RE: Crystal Vitoria Mine, File No. P-2025-004, Notice of Intent to Conduct Prospecting Operations, Notice of Deficiency

Below we have provided responses to the areas of concern from your May 19, 2025 letter.

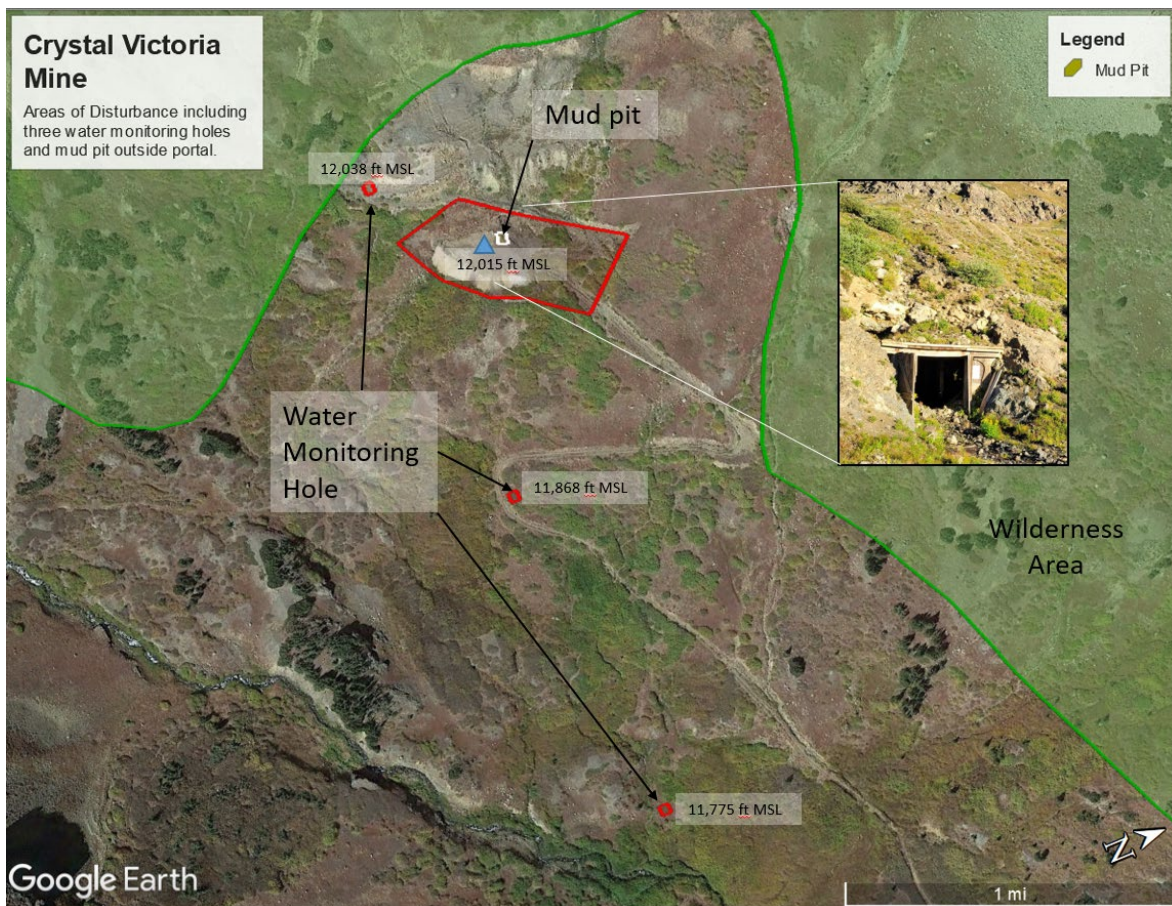
1. Question 3 states that approximately 5,000 tons of material will be extracted during the project. Please provide a narrative describing the anticipated makeup of that material as well as a plan on how the materials will be handled and or transported.

All material extracted during prospecting activities will be either drill core or channel samples taken from the underground workings. If 5,000 feet of core is successfully extracted, the total weight will be closer to 27 US tons of material. This material will be logged by a geologist and loaded on trucks to be assayed off site. Subsequent to assay, the core will be stored off site.

Figure 3: Water monitoring hole elevation in relation to the adit

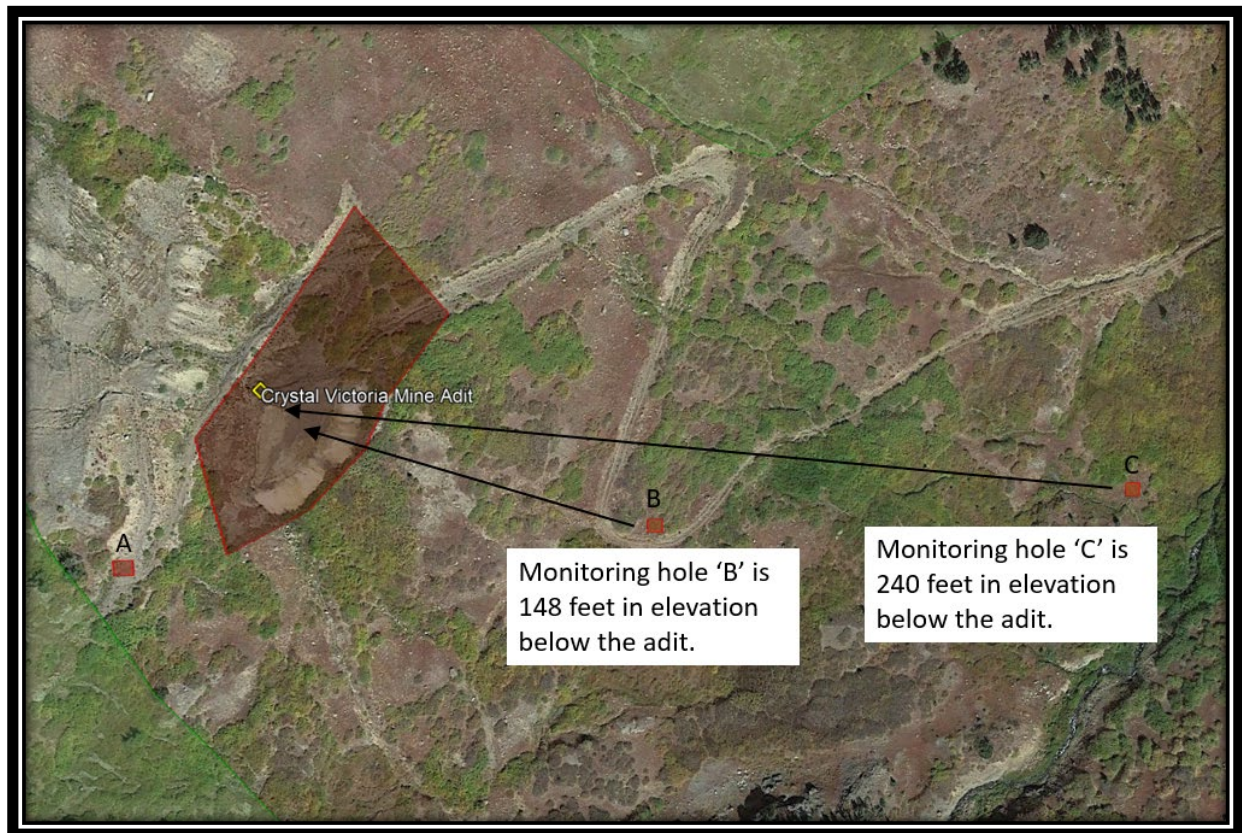
3. Additionally, in Question 6, A it is stated that there will be 12 holes with 5,000 feet depth listed. Through conversations the Division interprets this to mean 5,000 feet of total depth spread out between the 12 holes. Please confirm that the 5,000 feet is a total depth of all 12 holes and provide an estimate of the average depth of each drill hole. Additionally, please provide information regarding the underground location of each drill hole and their approximate angle of drilling.

The aggregated core will not exceed 5,000 feet across all twelve underground drill holes. The average depth of each hole will be 400 feet. The underground location of each of the twelve drill holes is yet to be determined by our geologist and will depend upon the assay results from a channel sampling program. It is anticipated the holes will all be horizontal or slightly inclined to intercept vein structures to the northwest. Both 'Jack's' and 'Vic's' structure (see map below) are oriented northeast to southwest. Each drill hole will terminate at an elevation above the furthest downslope water monitoring hole which lies 240 feet below (11,775' MSL) the underground workings (12,015' MSL).

The average depth of each drill hole will be 400 feet. The underground location of each of the twelve drill holes is yet to be determined by our geologist and will depend upon the assay results from a channel sampling program. It is anticipated the holes will all be horizontal or slightly inclined to intercept vein structures to the northwest. Both 'Jack's' and 'Vic's' structure (see map below) are oriented northeast to southwest. Each drill hole will terminate at an elevation above the furthest downslope water monitoring hole 'C' which lies 240 feet below (11,775' MSL) the underground workings (12,015' MSL). Monitoring hole 'B' lies 148 feet below the adit.
